ROLL-ON/ROLL-OFF BERTH
PORT OF UMM QASR, IRAQ

SUSTAINMENT ASSESSMENT

SIGIR PA-08-162
JULY 8, 2009

SUBJECT: Report on Roll-On/Roll-Off Berth, Port of Umm Qasr, Iraq
(SIGIR Report Number PA-08-162)

Figure 2. RORO Berth 22 overview (Courtesy of GRS)

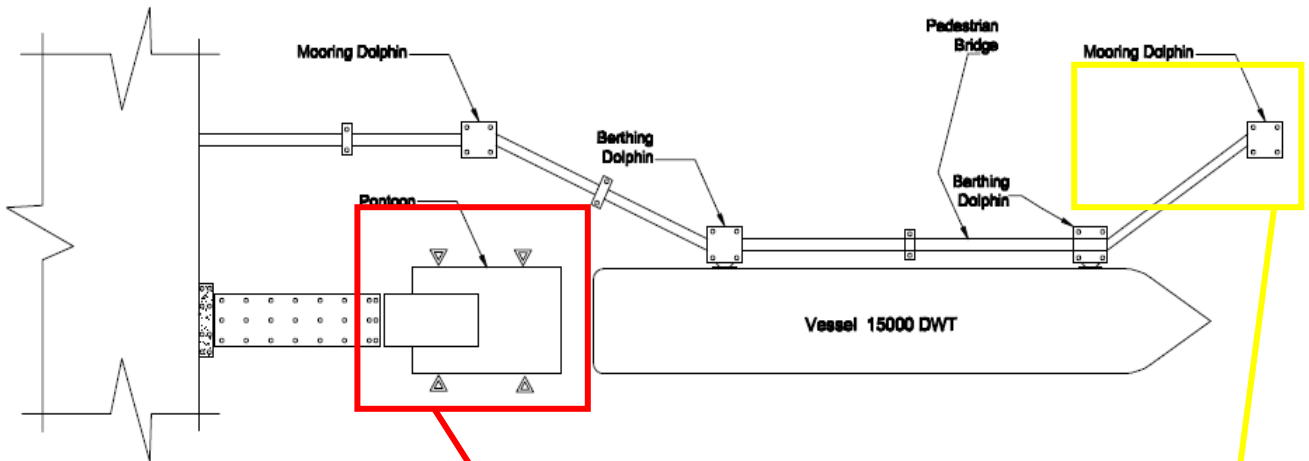
Figure 2 provides the design of the RORO Berth 22 project—a steel deck structure fixed to a concrete abutment and supported by piling. A pontoon is attached to the deck structure by a hinge mechanism, which can raise and lower according to the water level in the port (Site Photo 10). The pontoon has a steel deck structure, which allows ships to back up to the pontoon and load and unload cargo—rather than using a crane. This method of unloading is efficient for vehicles, passengers, and palletized cargo. The pontoon is affixed to four guide rail/roller assemblies, which allow the pontoon to raise and lower with the tide, but not to move laterally due to waves or ship movement.

Figure 3. Rails/rollers - enlarged (Courtesy of the USACE)

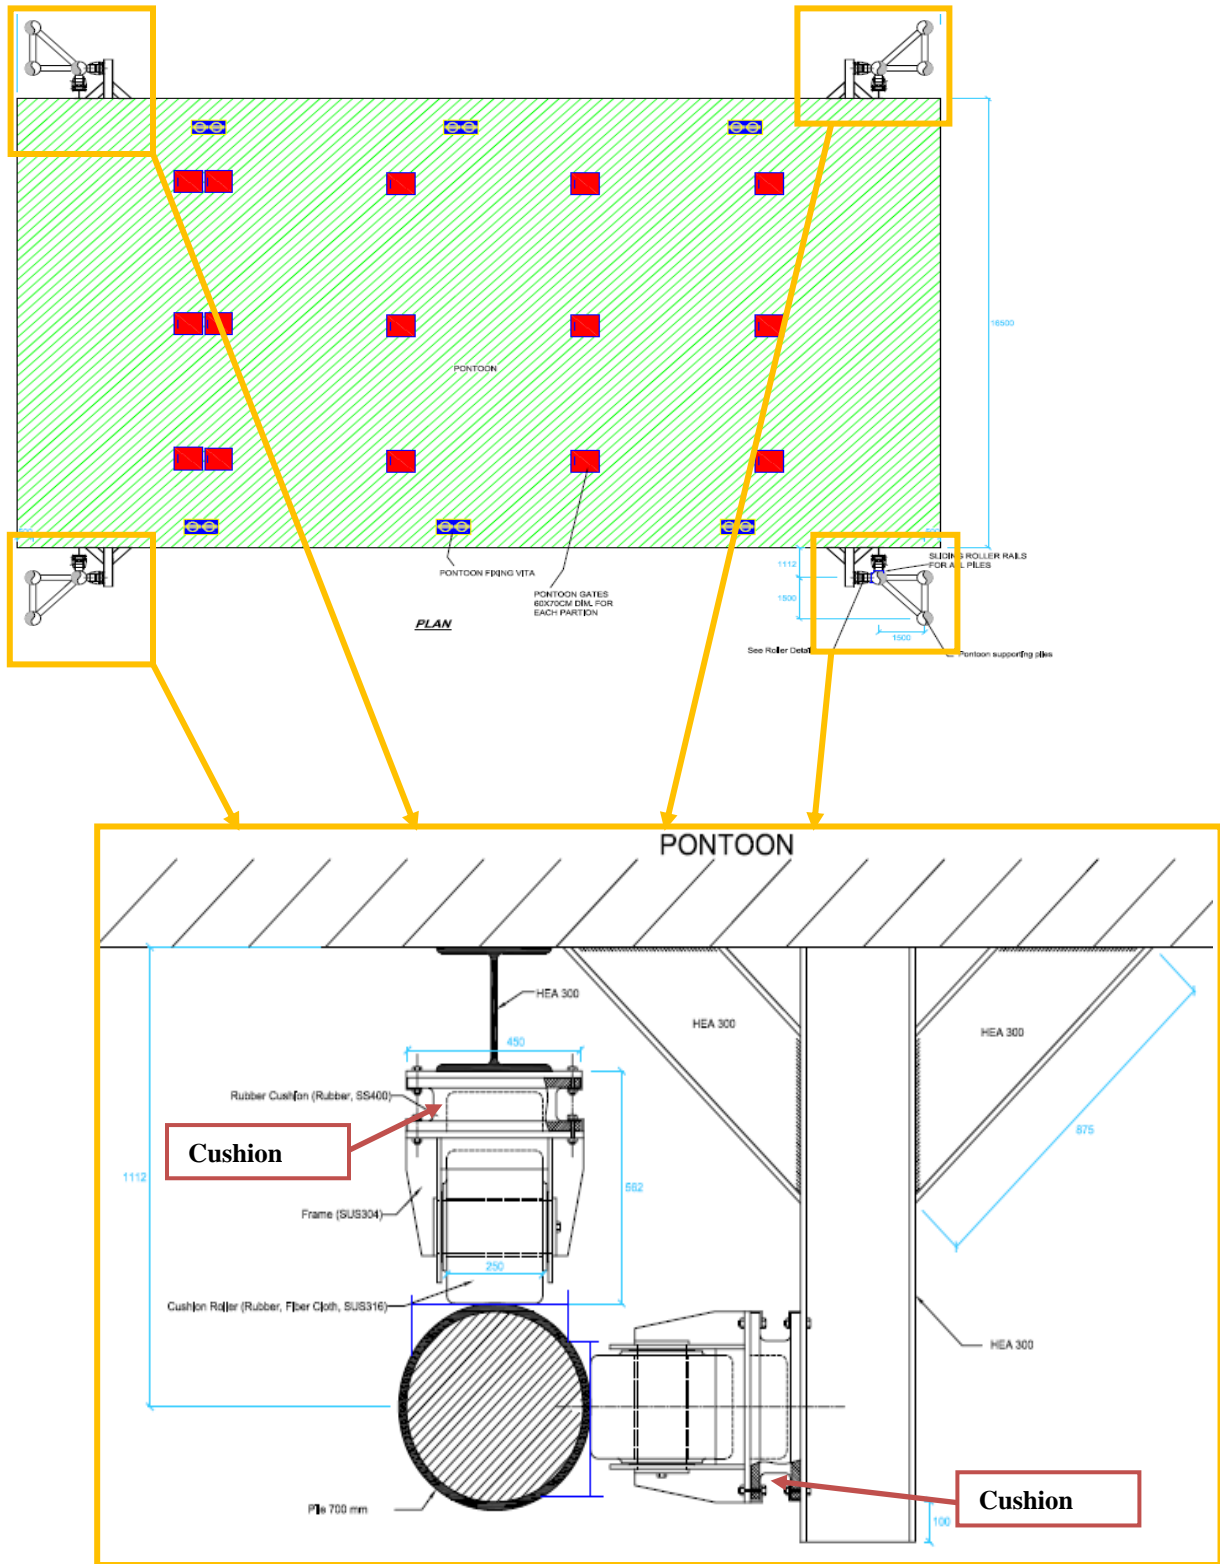
Originally, the contractor designed the cushion roller assemblies with flexible elastomeric mounts (cushions) (Figure 3). The mounts permit relative movement of the rollers and prevent binding on the vertical tracks caused by irregularities in the roller system geometry.

The contractor installed the cushion rollers with steel spacer plates over the elastomeric mounts (Site Photo 11). The purpose of the steel spacer plates is unknown; however, the steel spacer plates effectively negate any cushioning effect between the roller and the mounts. Without some flexibility of the roller assembly, any irregularity in the roller system geometry would increase the axial load and possibly bind the roller assembly.

If the roller assemblies become bound within the tracks, the steel cantilevers supporting the assemblies will be subject to torsion forces from the pontoon. Apparently, this has

occurred: the damaged steel cantilevers exhibit textbook torsion failure of a steel wide flange section with transverse tearing of the flange (Site Photo 12).

It does not appear that the original design intended for the steel cantilevers to resist torsional loading; nevertheless, because of the configuration of the cushion roller assembly, this should have been considered as a possibility. The wide flange shapes used in the design have minimal torsional capacity, which would make them an inappropriate selection. A better design would utilize a section with increased torsional resistance, such as a round or square tube section.

Once a cushion roller assembly is damaged, the change in load path for the remaining roller assemblies could result in overload and additional assembly failures. This appears to have occurred; the roller assemblies are damaged or missing at all four pontoon-supporting pile locations (Site Photo 13).

1. Pontoon guide rail and roller assemblies
2. Hinges that connect the steel structure decking and the pontoon decking
3. Two rubber fenders on the berthing dolphins

Site Photos 15 and 16. RORO Berth 22 sheared rubber fenders

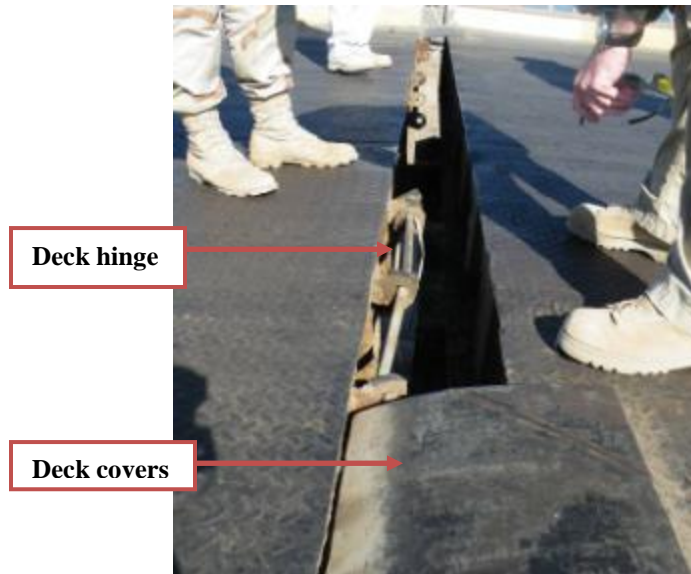
The design showed that RORO Berth 22 fenders were 600 mm high and 1150 mm long. At the time of the inspection, one of the rubber fenders on the first berthing dolphin had been severely damaged. The rubber fender appeared to be sheared off (Site Photos 15 and 16). The specific cause of the damage could not be determined; however, GRS personnel stated that the damage was caused by careless/rough operations by port personnel. In SIGIR's opinion, the damage was probably caused by ships approaching the dolphin too fast or poor mooring during storms. The damage will not have a significant impact on the operations of the facility; SIGIR considers this a minor maintenance issue.
